METROPOLITAN EDISON COMPANY
JERSEY CENTRAL POWER & LIGHT COMPANY
AND
PENNSYLVANIA ELECTRIC COMPANY
THREE MILE ISLAND NUCLEAR STATION, UNIT 1

Operating License No. DPR-50
Docket No. 50-289
Technical Specification Change Request No. 103

Technical Specification Change Request No. 103

Figure 2.3-1

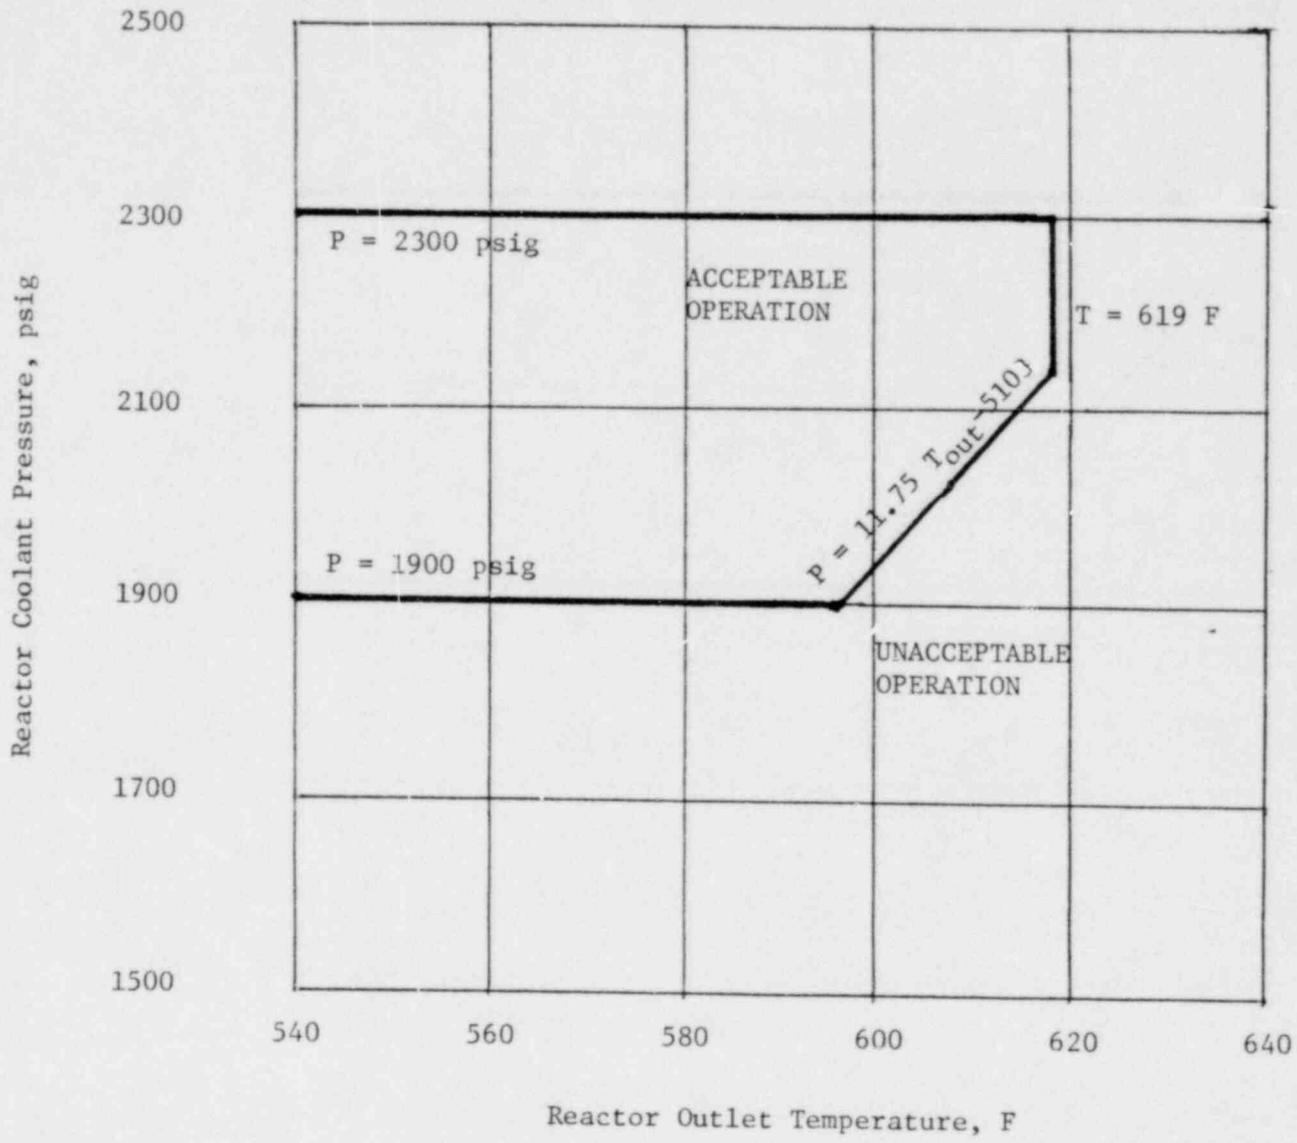
In addition, Technical Specification 2.3.1 (Table 2.3-1, Figure 2.3-1) provides a value of 1800 psig for the RPS Low Reactor Coolant Pressure trip setpoint. The B&W generic ECCS analysis, "ECCS Analysis of B&W's 177-FA Lowered Loop NSS," BAW-10103, Rev. 2, April 1976, referenced a value of 1900 psig for the Low Reactor Coolant System Pressure Trip setpoint based on trip on variable pressure/temperatures at full power. To cover operation at less than full power Technical Specification 2.3.1 increase the Low Reactor Coolant System Pressure Trip Setpoint from 1800 psig to 1900 psig.

The low pressure (1900 psig) and variable low pressure (11.75 T_{OUT} 5103) trip setpoint were established to maintain the DNB ratio greater than or equal to 1.3 for those design accidents that result in a pressure reduction (3,4). The B&W generic ECCS analysis however, assumed a low pressure trip of 1900 psig and is therefore the basis of low pressure reactor trip. Figure 2.3-1 shows the high pressure, low pressure, and variable low pressure trips.

In conclusion, with regard to increasing the Low Reactor Coolant Pressure trip (RPS) setpoint from 1800 psig to 1900 psig and increasing the minimum Low Reactor Coolant System (ESAS) channel setpoint from 1500 psig to 1600 psig:

Based upon the above, we conclude that increasing the Low Reactor Coolant System trip setpoint from 1800 psig to 1900 psig, and increasing the minimum Low Reactor Coolant System Pressure setpoint, does not involve unreviewed safety questions.
